**NORTH
NORFOLK
DISTRICT
COUNCIL**

Norfolk Boreas Offshore Wind Farm

REPRESENTATIONS FOLLOWING EXQ2 RESPONSES SUBMITTED AT DEADLINE 4

DEADLINE 6 – 05 MARCH 2020

REPRODUCED FROM ORDNANCE SURVEY MAPS WITH PERMISSION FROM THE CONTROLLER OF HM STATIONERY OFFICE. CROWN COPYRIGHT RESERVED. LICENCE No. 100023422 2007.

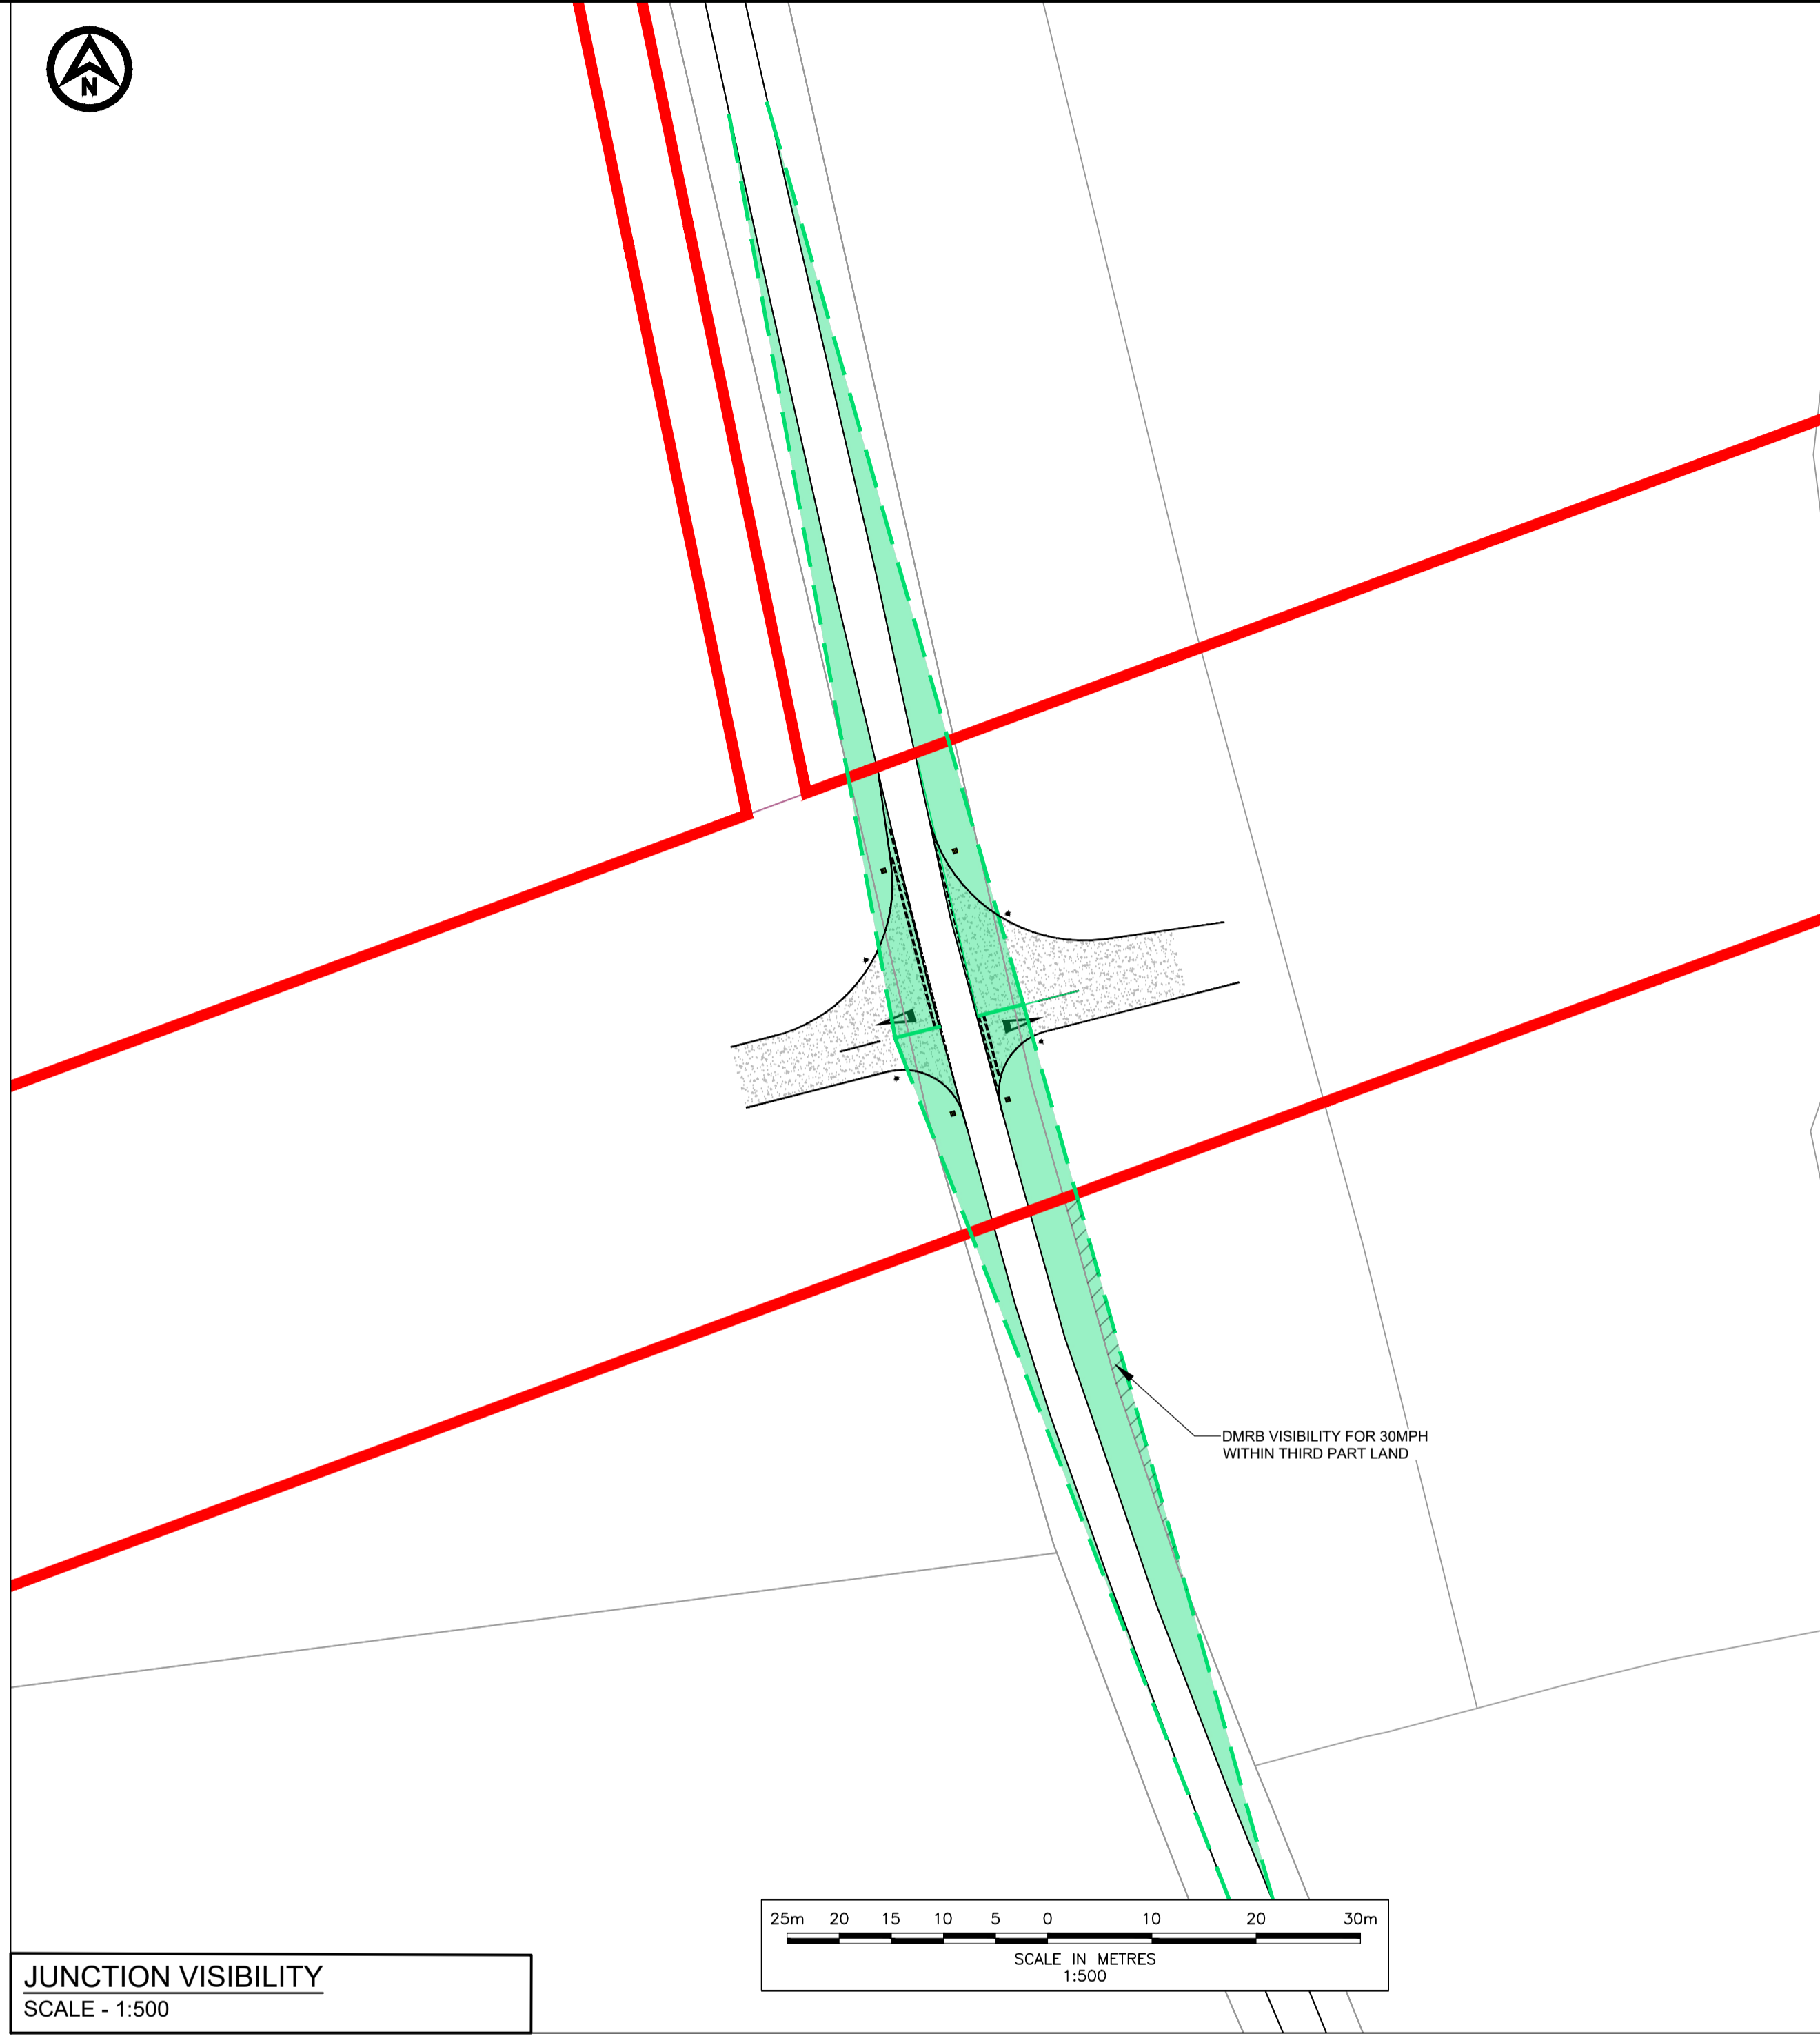
2.16. In respect of NNDC's proposed alternative solution to enable trenchless crossing under Church Road, Colby submitted at Deadline 5, following a teleconference with the applicant on 04 March 2020, NNDC understands that the applicant is considering the option presented and will provide further comment in due course.

- 2.4. In discussing this matter with the applicant, particularly with regard to alternative access points, NNDC has suggested consideration of an alternative vehicular access point to the north of the proposed cable corridor - see annotated plan of the proposal attached at **Appendix B** submitted to ExA for Norfolk Boreas at Deadline 5. This would be located at a point where there is an existing break in the tree line on the western side of Colby Road at the entrance to Hall Farm and Hall Farm Cottages. Existing access tracks could be partly used to form a new works access entrance with no loss of trees on this side of the road. On the eastern side of Colby Road, a new access could be created through the existing hedge. Whilst this may require removal of one or two semi-mature trees, the advantage of using this location is that replacement trees (and hedging) could be planted where gaps are created because the access would fall outside of the permanent easement area. These two accesses could allow new running track to be laid which will enable access to the trenchless crossing under Colby Road and thus negating the need to remove sections of three Important Hedgerows No.77, 78 and 79.

Title: **2.11 Important hedgerows plan (sheet 13 of 42)**

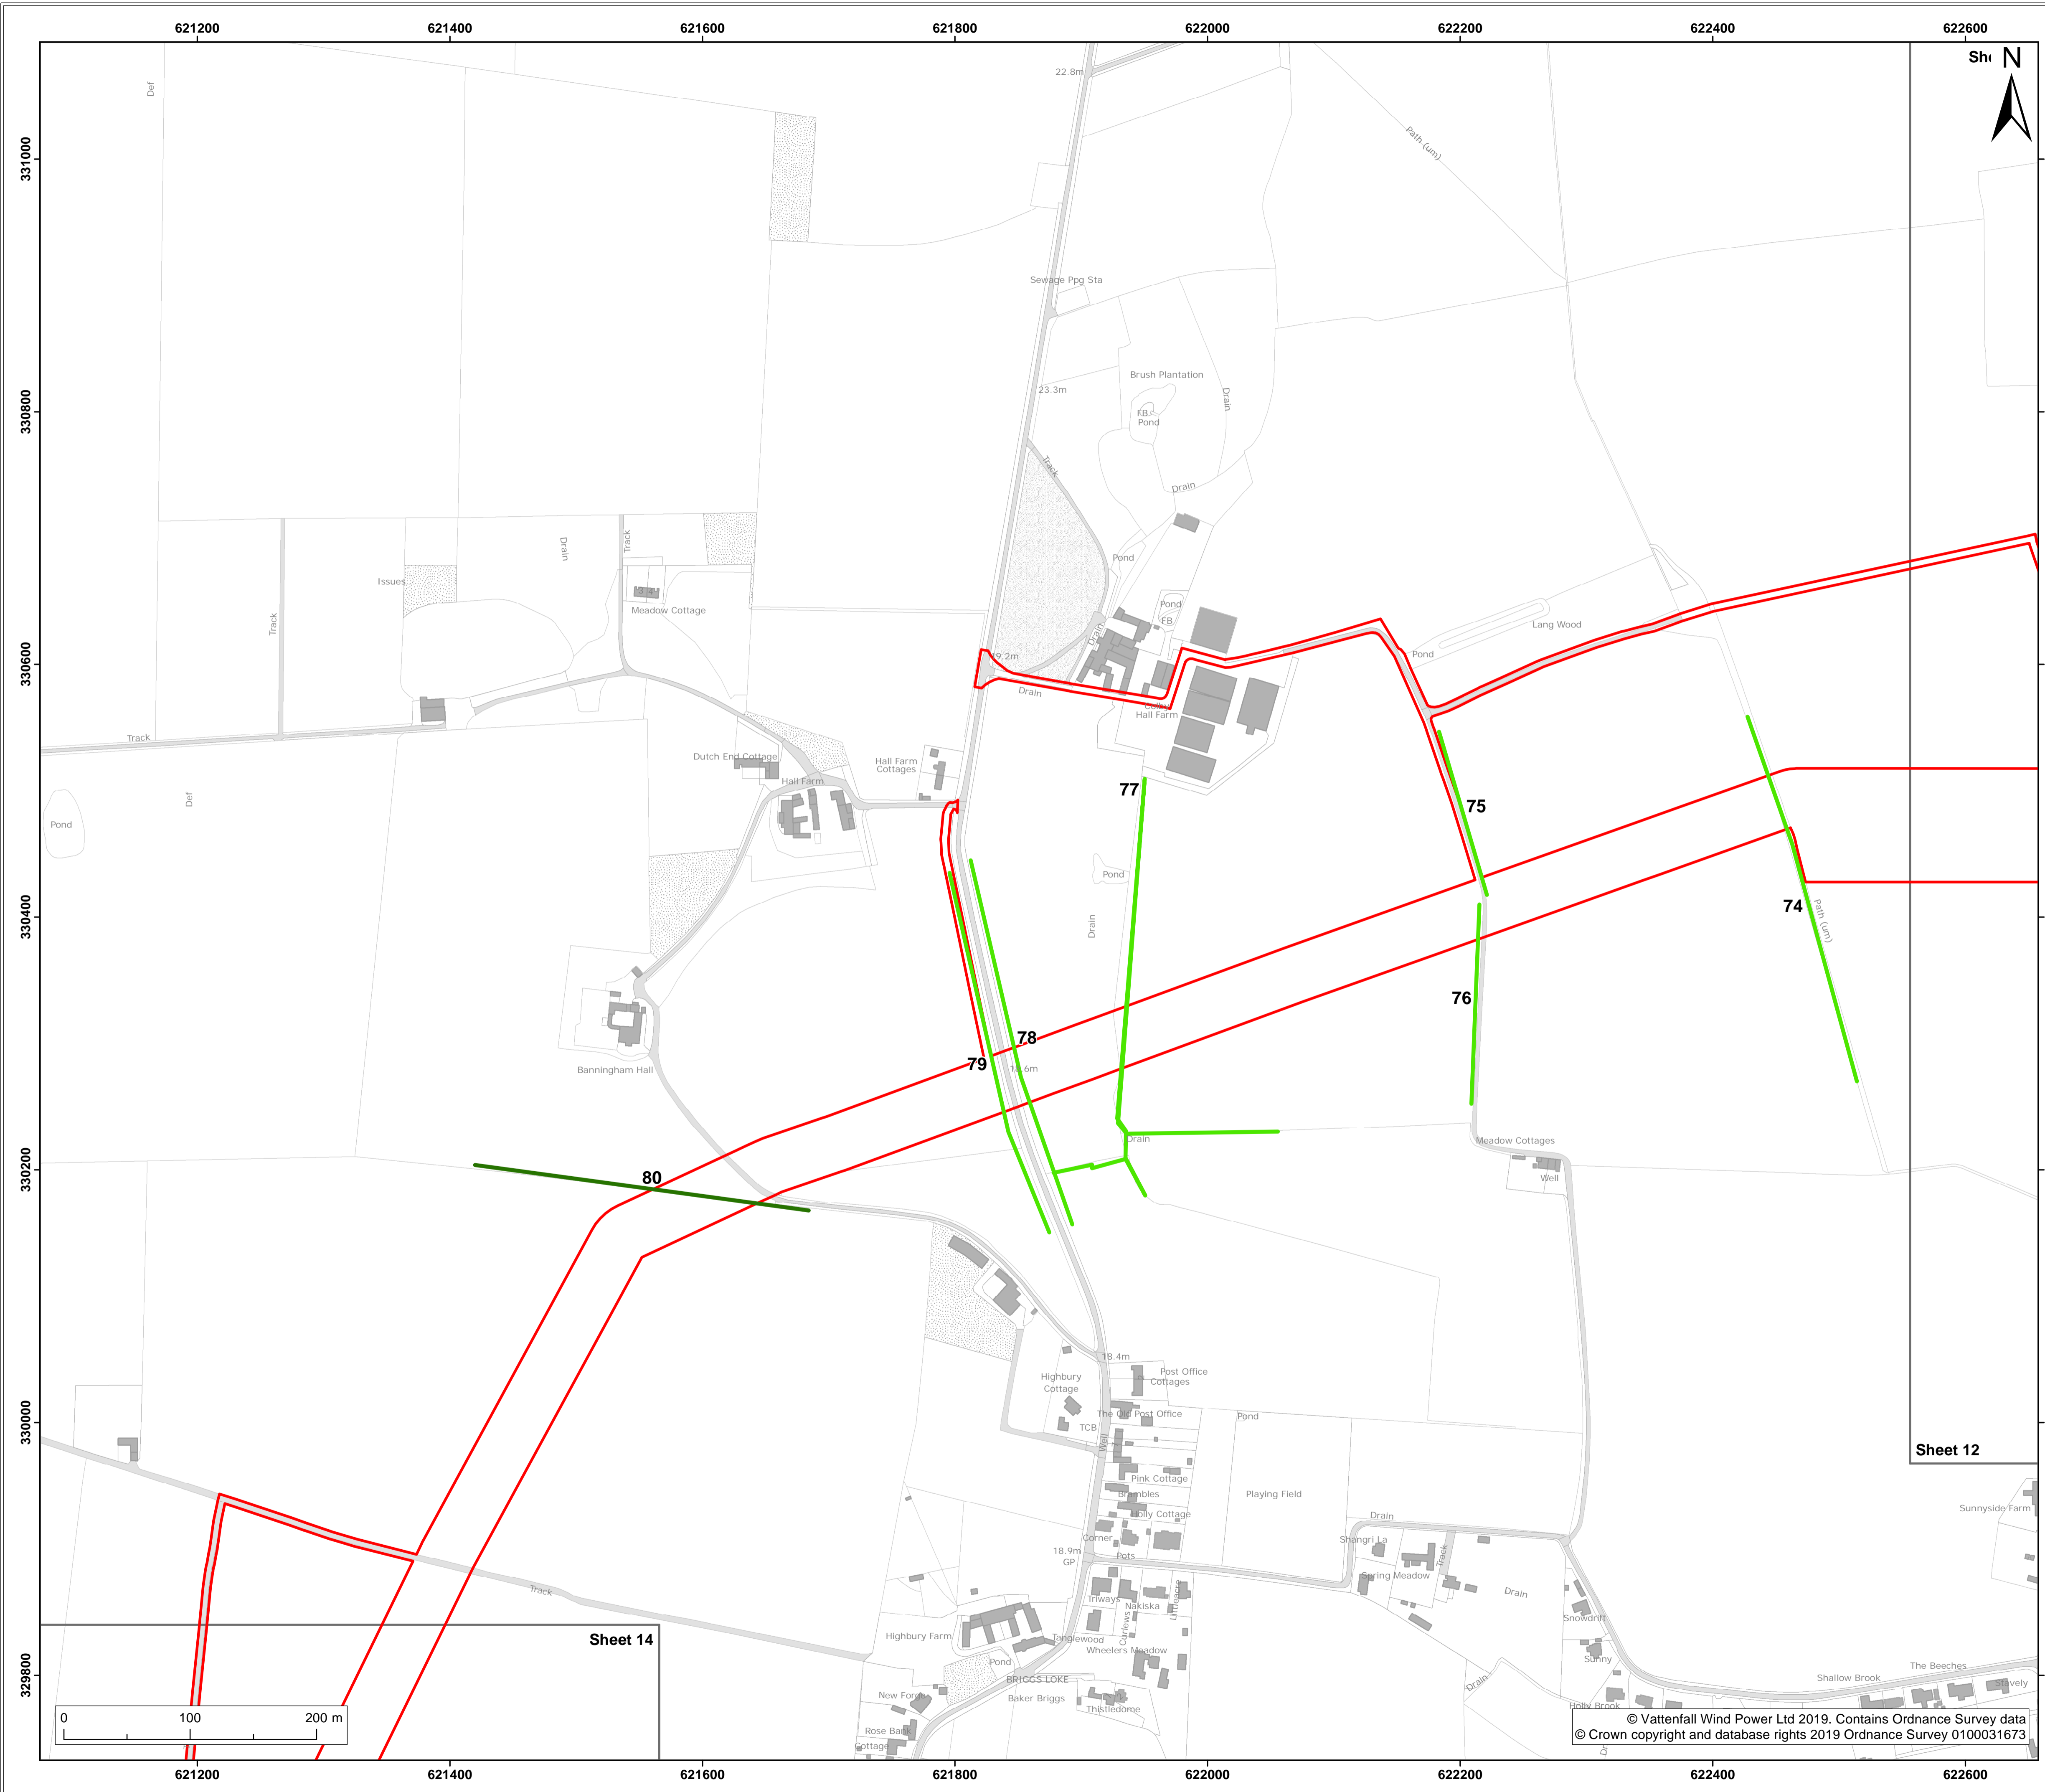
- 2.1. NNDC are grateful that the Secretary of State recognises the concerns of NNDC regarding proposals at Church Road, Colby. What is at stake here is avoiding disturbance of three out of six Important Hedgerows along this part of the route as well as the integrity of the tree lined road. The character of Colby Road would be permanently affected by the open cut trenching option proposed by the applicant with permanent easements preventing replacement trees being planted in the same or similar locations.
- 2.2. In relation to Norfolk Boreas, NNDC has considered the applicant's Clarification Note submission in relation to trenchless crossing at Church Lane, Colby [REP4-017] See **Appendix C**. NNDC notes the position of the applicant as set out across paragraphs 32 to 44 of this document. In the context of considering this

document, the ExA should be aware of the Important Hedgerows Plan prepared by the applicant for Norfolk Boreas [APP-018] (see **Appendix D**) where sheet 13 of 42 relates to the Colby Road area. This plan identifies six 'Important Hedgerows' affected by the project in this area alone.
